Re: Four Winds International Corporation Recall
Defect and Non-Compliance Report

Recall Campaign No: TBD
Four Winds International Corporation File Number: R030009
Bolting the Seat Belt Harness

**Re: Four Winds International Corporation
Recall No.: 04V-127**

Regarding: Recall 04V-127 – Amended Scope of Affected Units/Instructions

**DIAGRAM 1-1**

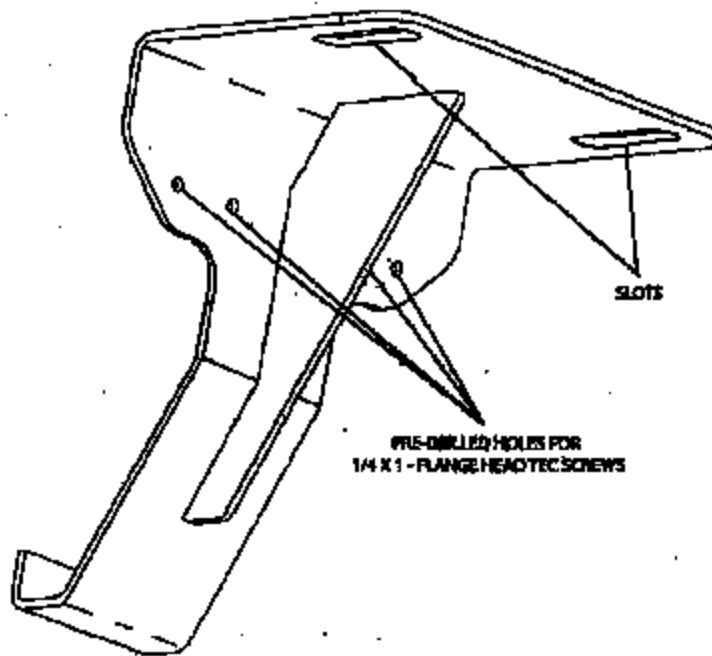
Identify the brace, and inspect, insuring that there are 4 (four) 1/4 X 1 - Flange Head Tec Screws securing the brace to the motor home chassis frame. If there are less than 4 (four) screws, proceed to secure the brace using 1/4 X 1 Flange Head Tec Screws (refer to diagram 1-1). If upon inspection a seat pedestal brace is not present refer to diagram 1- 2 of this installation guide.

DIAGRAM 1-2

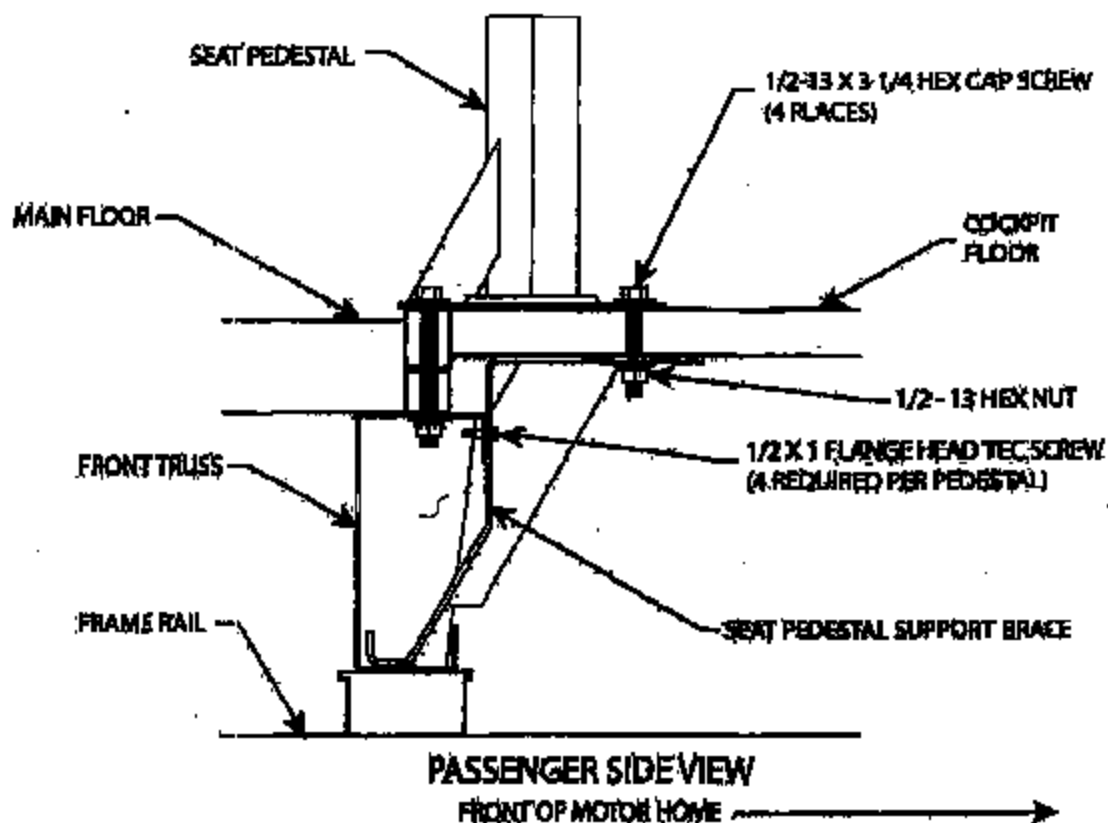
Upon inspection, if a seat pedestal brace is not present, installation of the brace is required immediately.

To proceed with installation, remove the seat pedestal's front 1/2 -13 Hex Nuts from the 1/2 -13 Hex Cap Screws, as well as the 1/2 Lock Washers and the 1/2 Flat Washers, which secure the seat pedestal to the doghouse frame.

Place the brace slots over the Hex Cap Screws. Replace the Flat Washer, followed by the Lock Washer and then the Hex Nut. Hand tighten the Hex Nut. Insure the back of the brace is flush with the front truss of the chassis frame.

Using the 1/2 X 1 Flange Head Tec Screws, fasten the brace to the front truss (refer to diagram 1-1).

Torque the hex screw and nut to 65 lb.ft. Repeat procedure for the opposite seat pedestal.

DIAGRAM 1-1

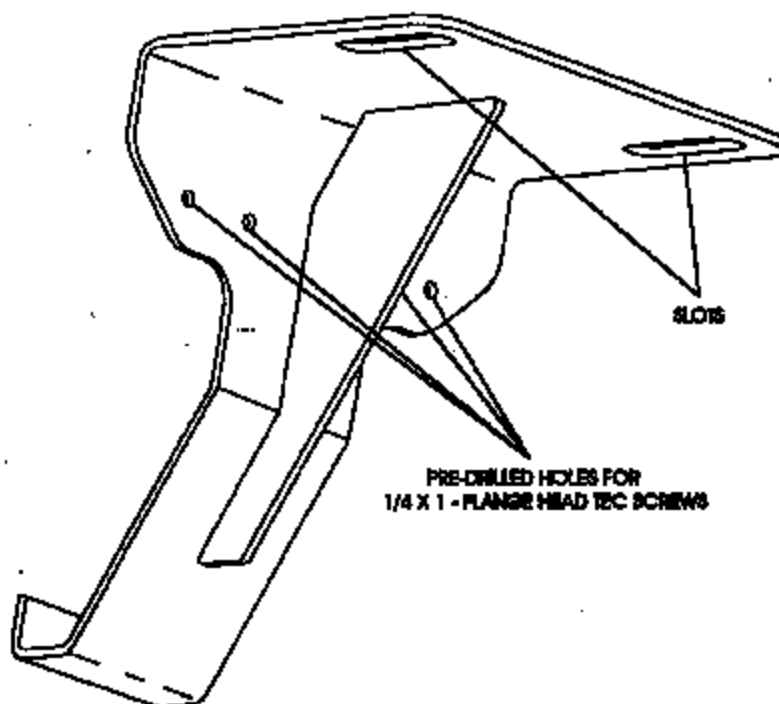
Identify the brace, and inspect, insuring that there are 4 (four) 1/4 X 1 - Flange Head Tec Screws securing the brace to the motor home chassis frame. If there are less than 4 (four) screws, proceed to secure the brace using 1/4 X 1 Flange Head Tec Screws (refer to diagram 1-1). If upon inspection a seat pedestal brace is not present refer to diagram 1-2 of this installation guide.

DIAGRAM 1-2

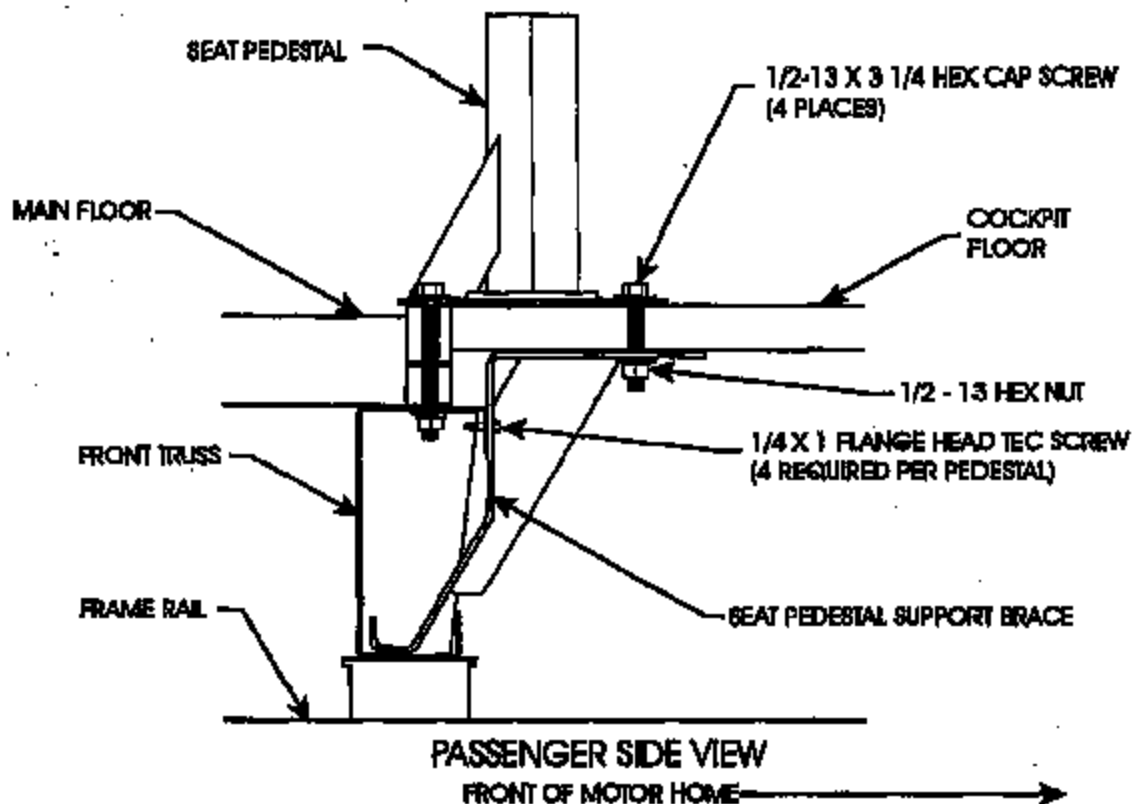
Upon inspection, if a seat pedestal brace is not present and the vehicle is equipped with a 3-point harness, installation of the brace is required immediately.

To proceed with installation, remove the seat pedestal's front $\frac{1}{2}$ -13 Hex Nuts from the $\frac{1}{2}$ -13 Hex Cap Screws, as well as the $\frac{1}{4}$ Lock Washers and the $\frac{1}{2}$ Flat Washers, which secure the seat pedestal to the doghouse frame.

Place the brace slots over the Hex Cap Screws. Replace the Flat Washer, followed by the Lock Washer and then the Hex Nut. Hand tighten the Hex Nut. Insure the back of the brace is flush with the front truss of the chassis frame.

Using the $\frac{1}{4}$ X 1 Flange Head Tec Screws, fasten the brace to the front truss (refer to diagram 1-1).

Torque the hex screw and nut to 85 lb.ft. Repeat procedure for the opposite seat pedestal.

DIAGRAM 1-3

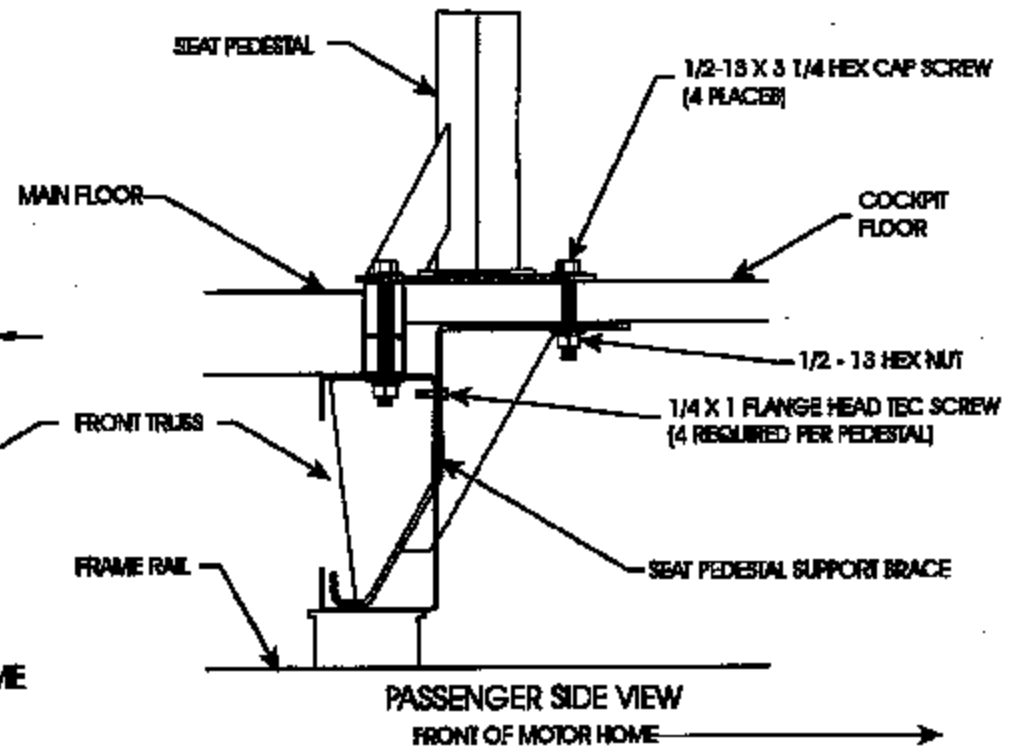
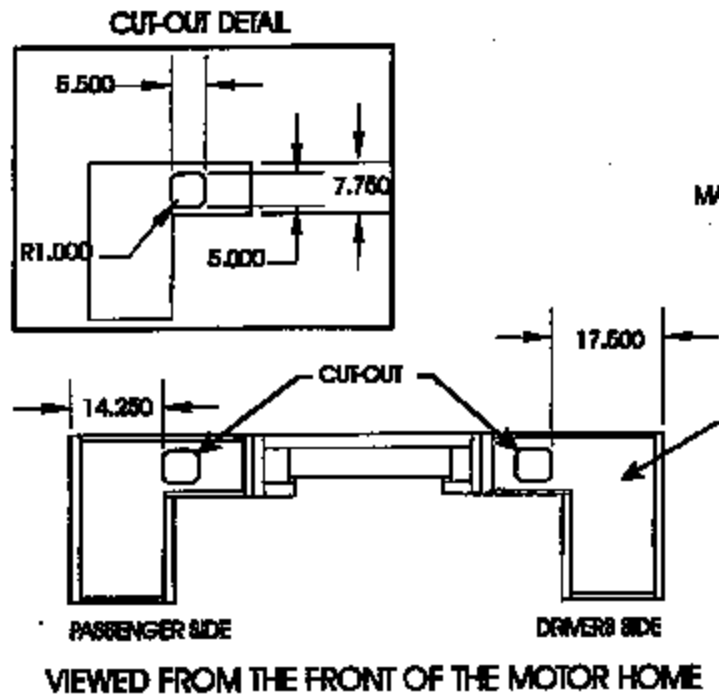
Locate and identify the chassis Front Truss. To allow proper installation of the Seat Pedestal Brace a section of the Front Truss will need to be cut-out by the use of a plasma cutter (refer to diagram 1-3 for proper cut-out location).

DIAGRAM 1-4

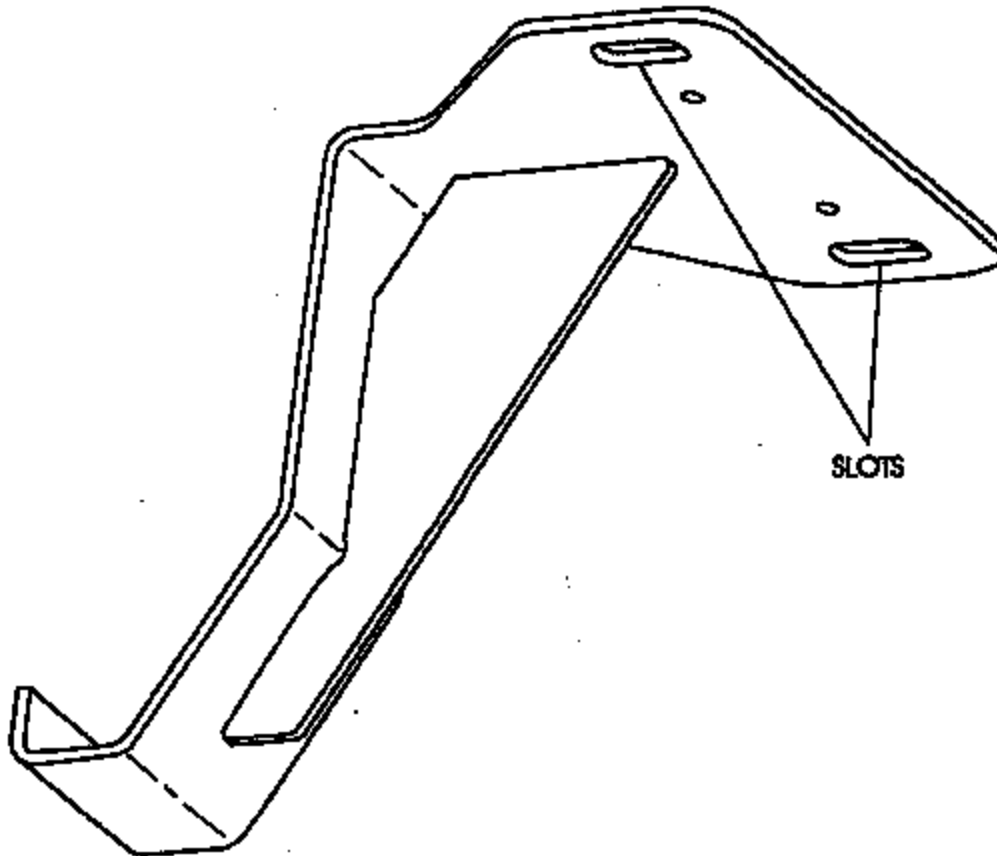
Place the brace slots over the Hex Cap Screws (refer to diagram 1-4). Replace the Flat Washer, followed by the Lock Washer and then the Hex Nut. Hand tighten the Hex Nut. Ensure the brace is positioned as far towards the rear of the motor home as the slots will allow.

DIAGRAM 1-5

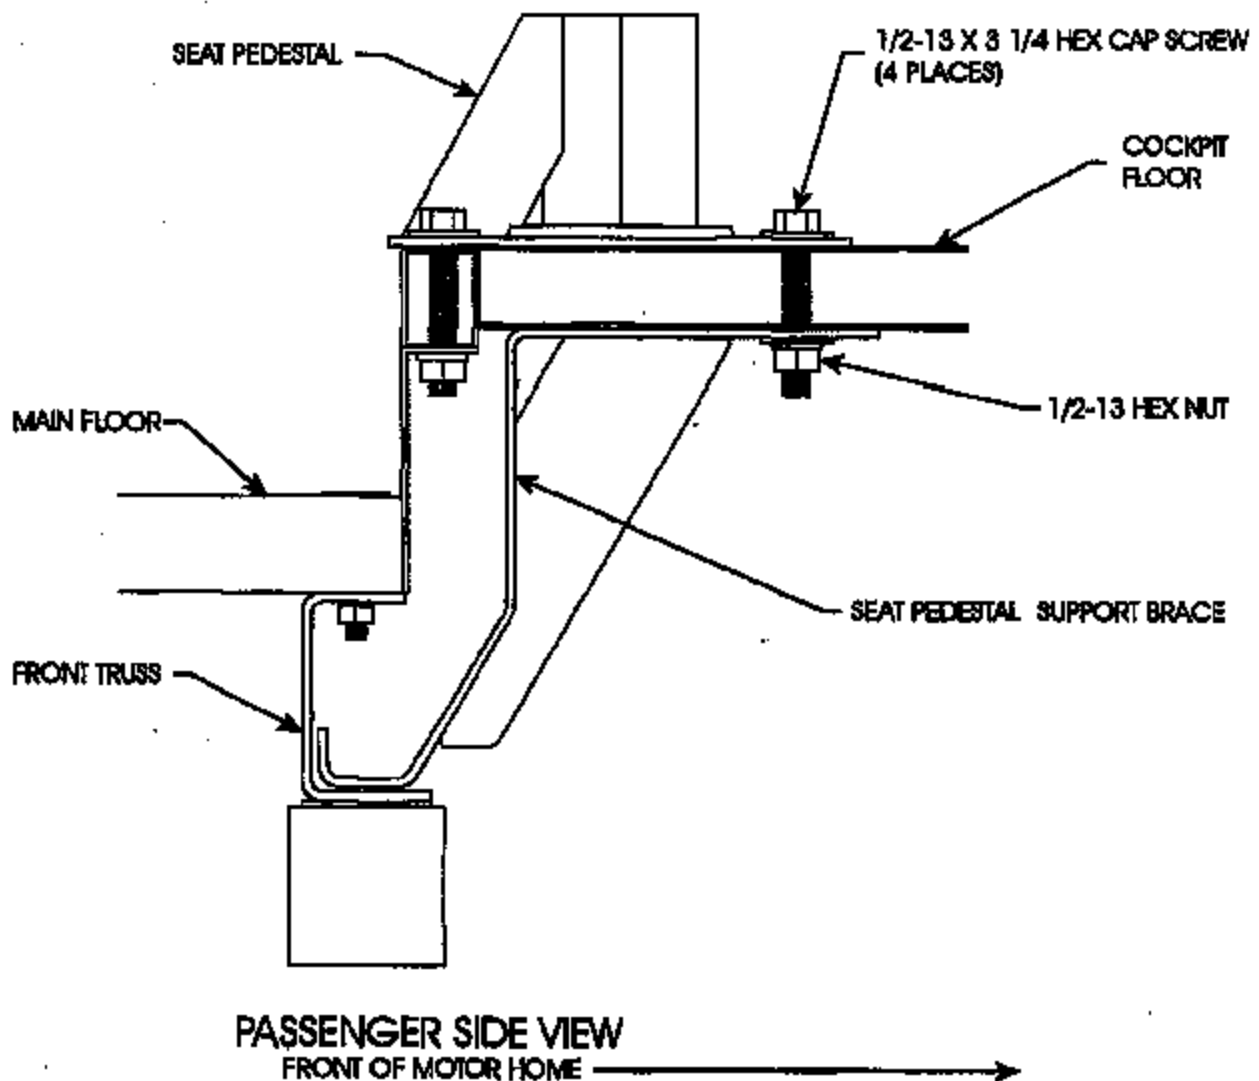
Upon inspection, if a seat pedestal brace is not present and the vehicle is equipped with a 3-point harness, installation of the brace is required immediately (refer to diagram 1-5).
